RESPONSE TO COMMENTS FOR THE TECHNICAL DRAINAGE STUDY FOR

SUMMERLIN WEST VILLAGE 29 PHASE I INFRASTRUCTURE

62029-204

Re: Response to City of Las Vegas Comments on the Technical Drainage Study for Summerlin West Village 29 Phase I Infrastructure (DS5501)

Cross Section for Section 3 Int - 100yr

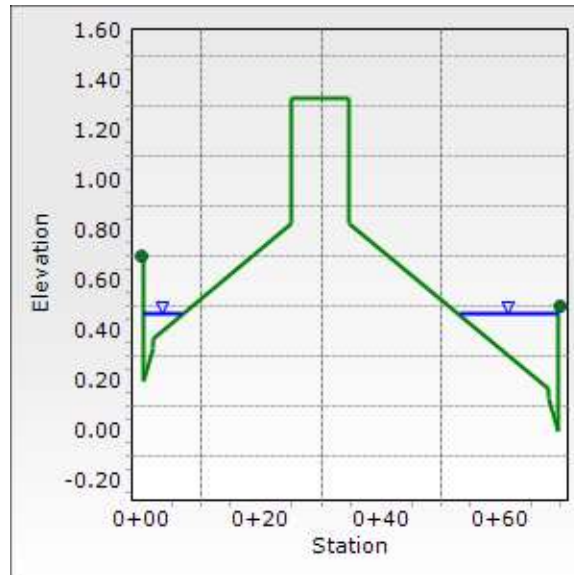
FIGURE 5: The calculations for Hydraulic Section 3 show a depth of 0.52', not 0.50' as shown on the exhibit, this exceeds the curb height of 0.5'. As a general rule in Summerlin, the 100-year flow in the streets cannot overtop the street curb. Review and revise accordingly.

Drop Inlets #7 and #8 have been upsized to 22.5 feet to capture all the runoff upstream of Section 2. As a result, depth at Section 3 has been lowered below 0.5 feet.
